# Keystone RV Company

## SAFETY ADVISORY # 25-468

### MORryde Clip-on Step Brackets

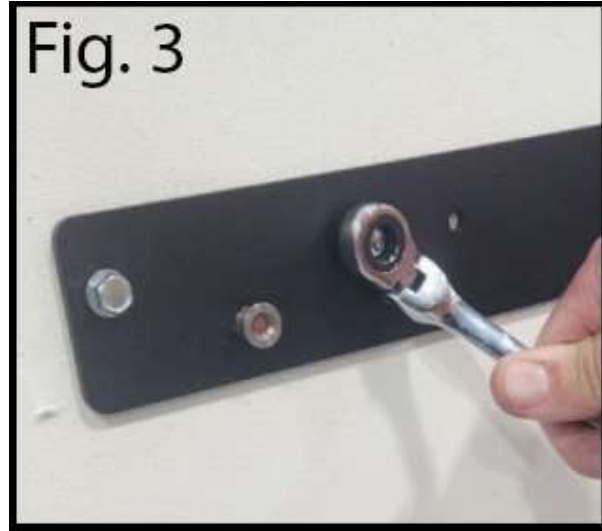
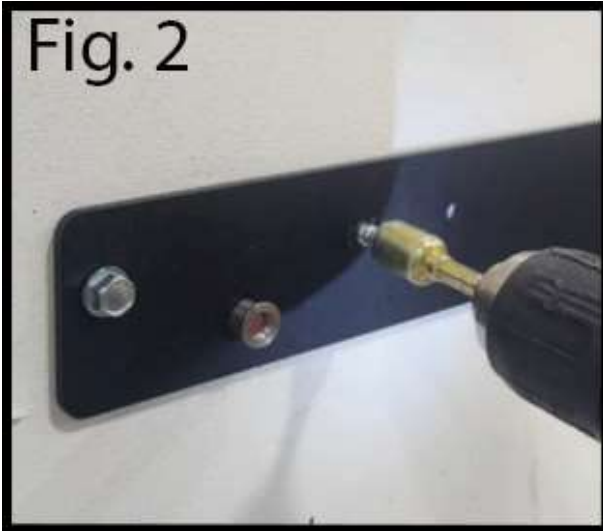
Remove the four mounting screws that secure the mounting bracket. Once removed, discard the original mounting bracket. See Figure 1.

Use the replacement kit KRV # 768047 to attach the new mounting bracket. To install the new bracket, start by installing four mounting screws into the four original holes. The above-mentioned holes will line up with the holes from the bracket that was removed. See Figures 2 & 3.

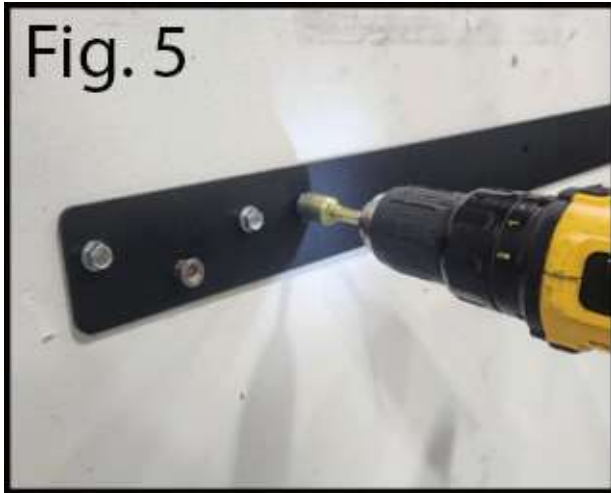
Use a drill and 3/16" drill bit to pre-drill pilot holes for the three new holes. See Figure 4.

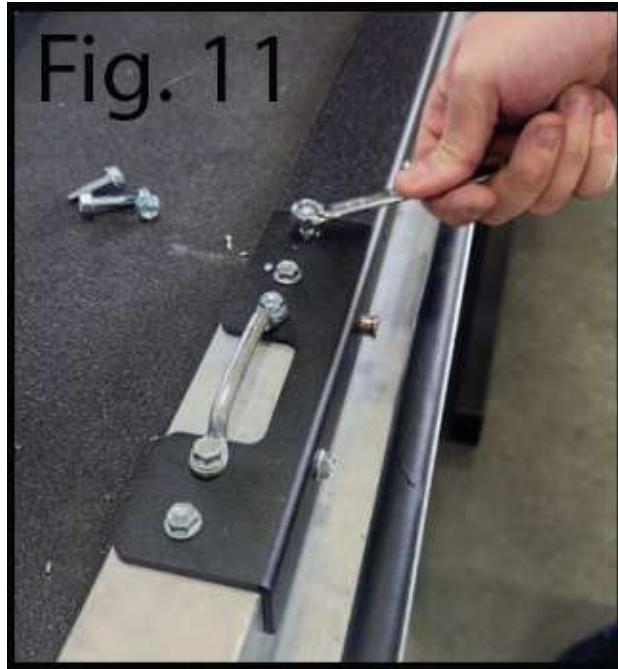
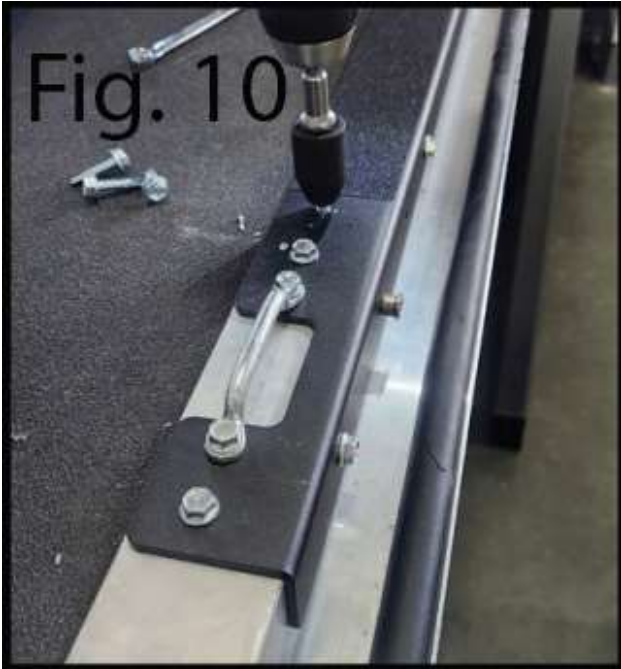
Use the replacement kit KRV # 768048 to attach the new mounting bracket. To install the new bracket, start by installing 12 mounting screws into the 12 original holes. The above-mentioned holes will line up with the holes from the bracket that was removed. See Figure 9.
